**Appl. No.** : **10/671,179**  
**Filed** : **September 25, 2003**

### **AMENDMENTS TO THE DRAWINGS**

### **REMARKS**

FIG. 2  
(PRIOR ART)

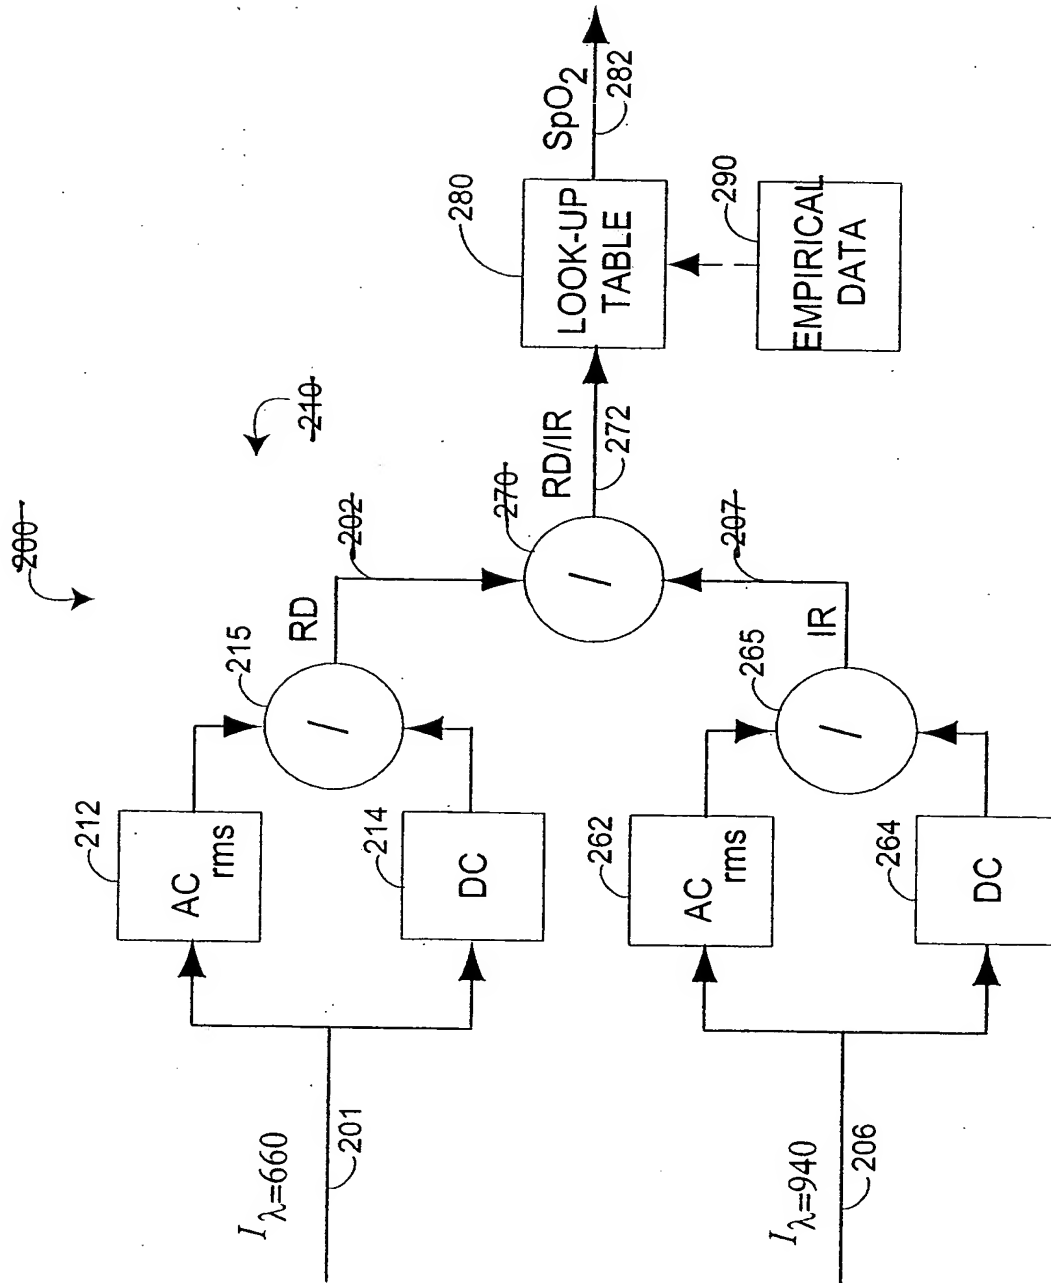
The attached sheets of drawings include changes to Figs. 2, 4, 5, and 9. The sheets, which include Figs. 1-10, replace the original sheets including Figs. 1-10. In Figure 2, reference characters 200, 202, 207, 210 and 270 have been deleted. In Figure 4, reference character 422 has been deleted. In Figure 5, reference characters 569 and 550 have been deleted and reference character 400 has been changed to 500. In Figure 9, reference character 932 has been deleted.

The Office Action dated March 3, 2006 objected to the drawings because they included reference characters not mentioned in the specification. In particular, in Figure 2, reference characters 200, 202, 207, 210, and 270 are not mentioned in the description. In Figure 4, reference character 422 was not mentioned in the description. In Figure 5, reference characters 569 and 550 were not mentioned in the description. In Figure 9, reference character 932 was not mentioned in the description. In addition, Applicant has amended Figure 5 to change reference character 400 to 500. Figures 2, 4, 5, and 9 have been replaced in the attached document entitled "*Submission Of Replacement Drawings For Approval By Examiner*," to show the above mentioned changes to the reference characters of the drawings.

FIG. 5

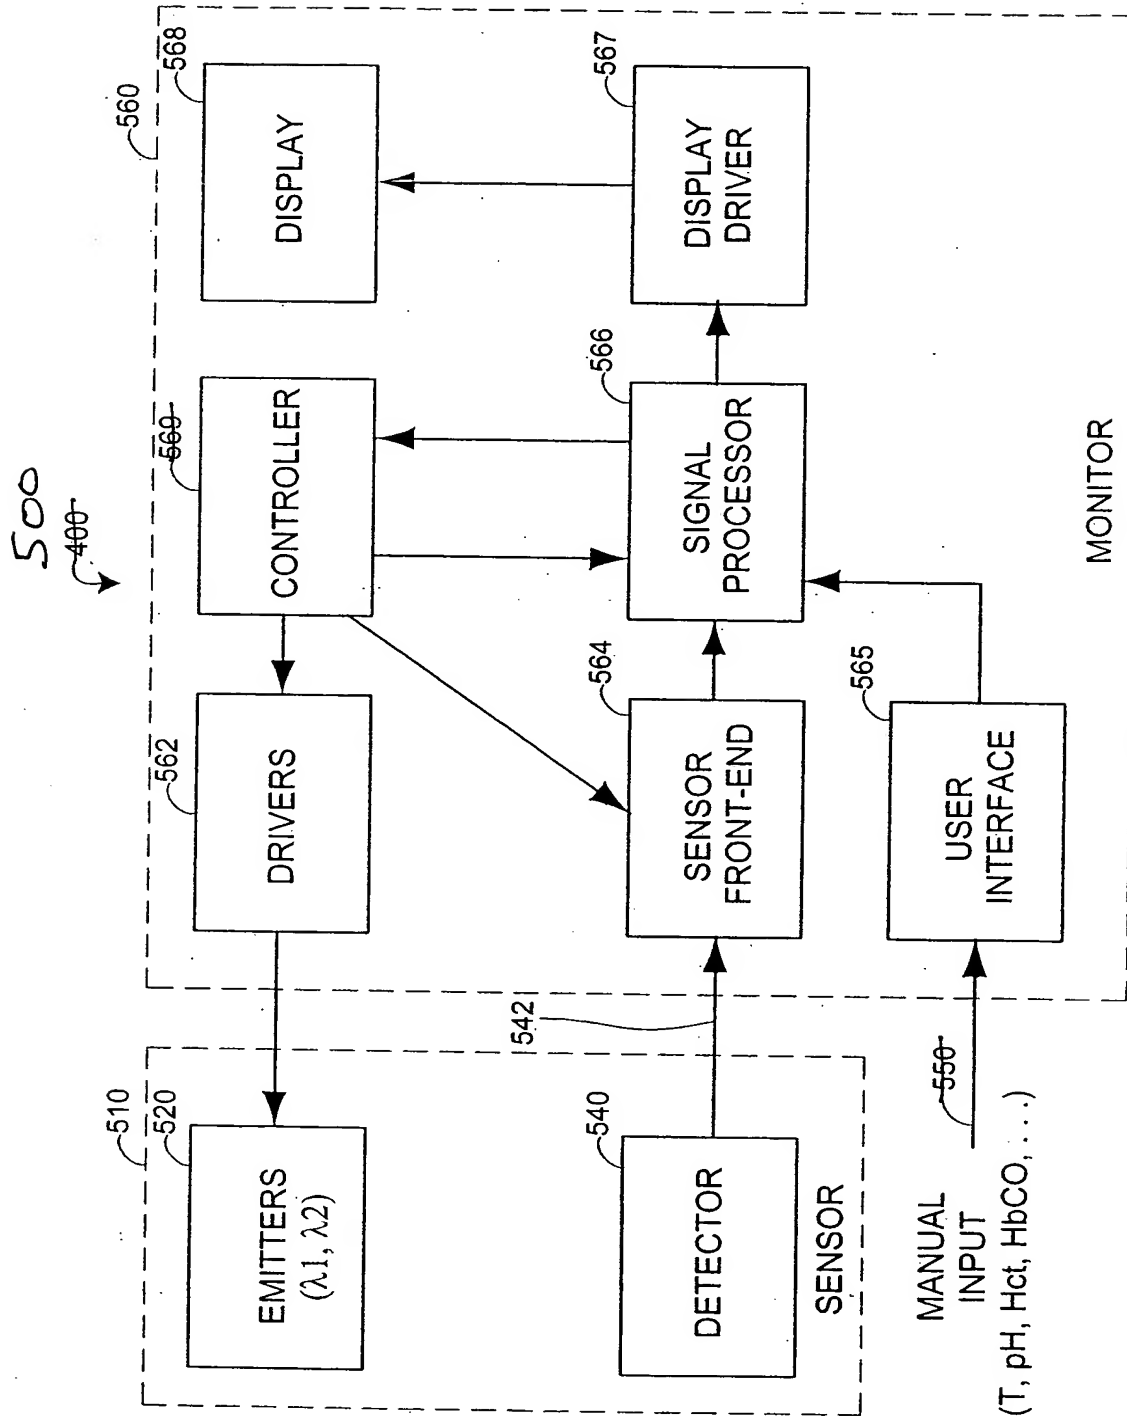
The drawing amendment to Figure 5, changing reference character 400 to 500 is supported in the description at paragraph 29. The originally filed specification states "FIG. 5 illustrates one embodiment of a parameter compensated pulse oximeter **500** having a sensor **510** and manual inputs to a monitor **560**."

FIG. 4

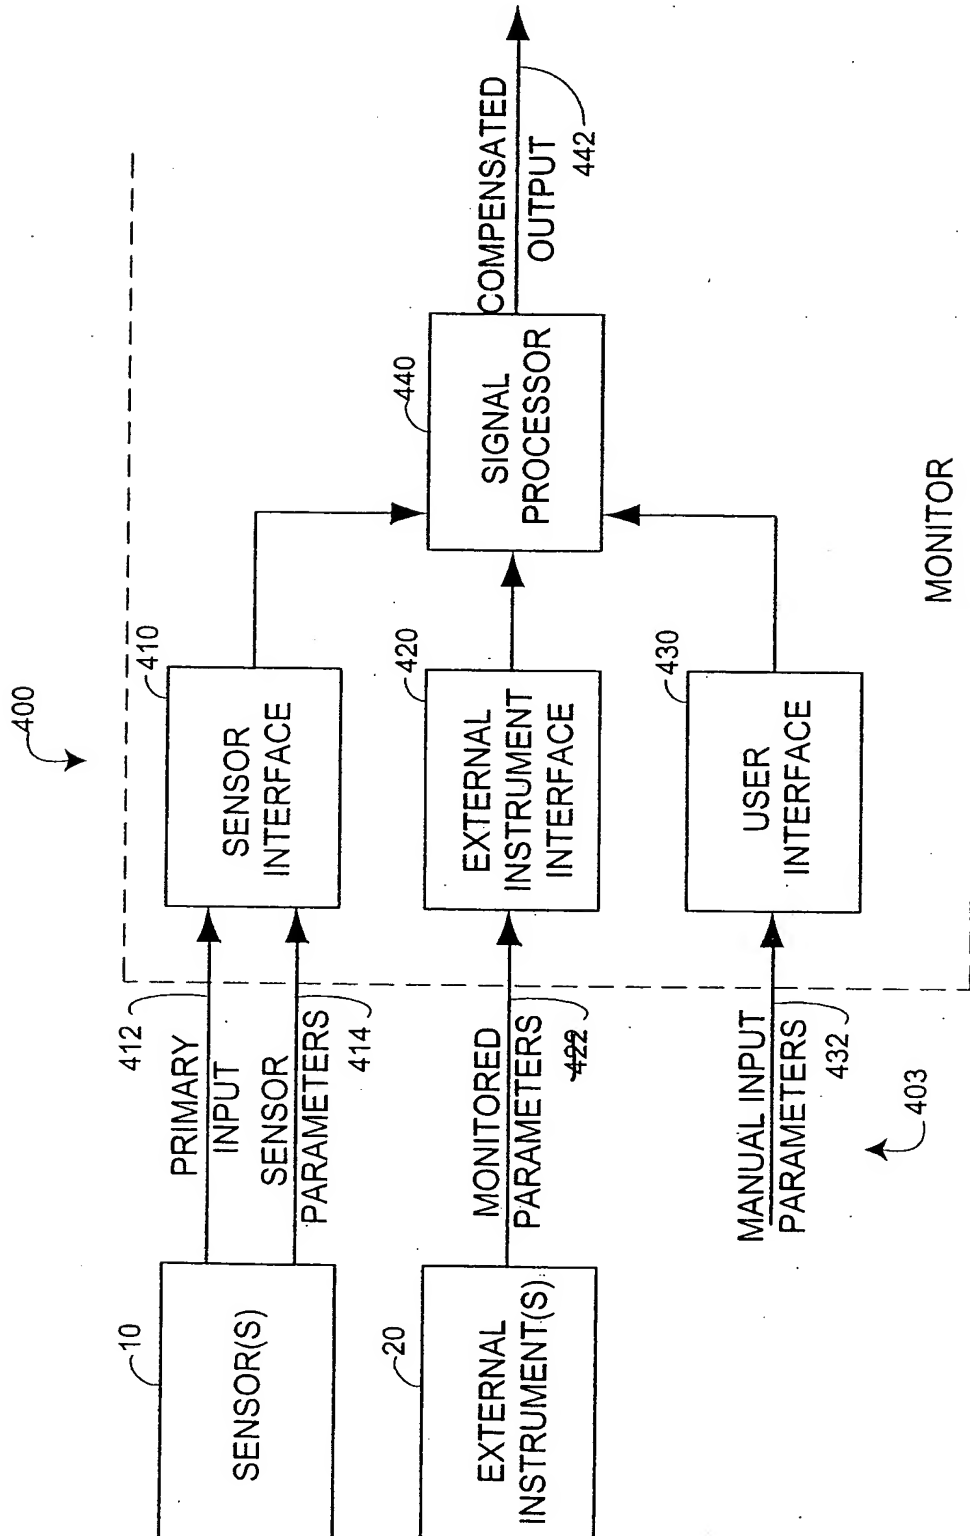
The Applicants have amended paragraph 26 of the specification to refer to reference character 420 instead of 620. The Applicants respectfully submit that no new matter is being introduced by way of this amendment.
